Winnebago Industries, Inc. has started a recall campaign. 00V-378

SUBJECT: Campaign #77 - Overload of Front Tires

Replacement of Front Tires and Air Springs on a Limited Number of Ultimate Advantage Motorhomes with I-Beam Front Axle

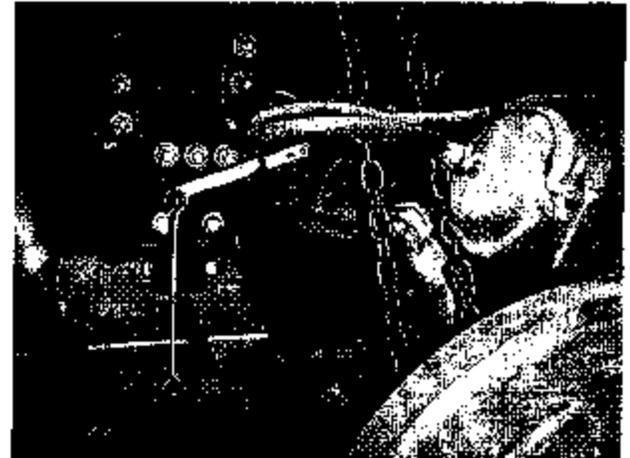
The basic procedure involves replacing the front air springs with larger capacity air springs, then replacing the existing front tires with wider tires. Finally, a poppet valve kit must be installed in the steering gear and adjusted to TRW specifications.

- Raise the coach on a hoist and support the frame to allow lowering the front axle assembly. (See photo 1 for example).

Remove the front air springs as shown in photo 2. Pry bar may be necessary to loosen base from axle.

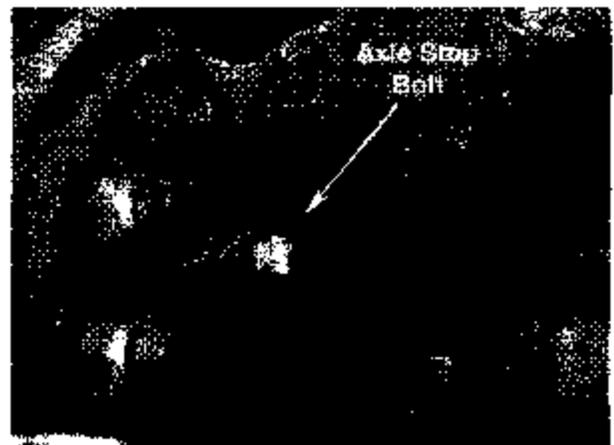
- Remove existing front tires and replace with new 275/80R22.5 Michelin™ LRG XZE tires.
- Be careful not to mar surfaces of the aluminum rims.
- Balance tires before installing onto coach.
- Torque wheel nuts to proper specs according to number of bolts.

8-Bolt:	280 – 310 Ft. Lbs.
10-Bolt:	450 – 500 Ft. Lbs.
- Be sure decorative 'acorn nut' caps are replaced securely.
- Adjust axle stop bolt on inboard side of brake plate (both LH and RH sides) so that there is 1"– 1 ¼" clearance between tire and chassis components to avoid rubbing. (see photo).
- Torque the stop bolt jam nuts 50–65 ft.lbs.
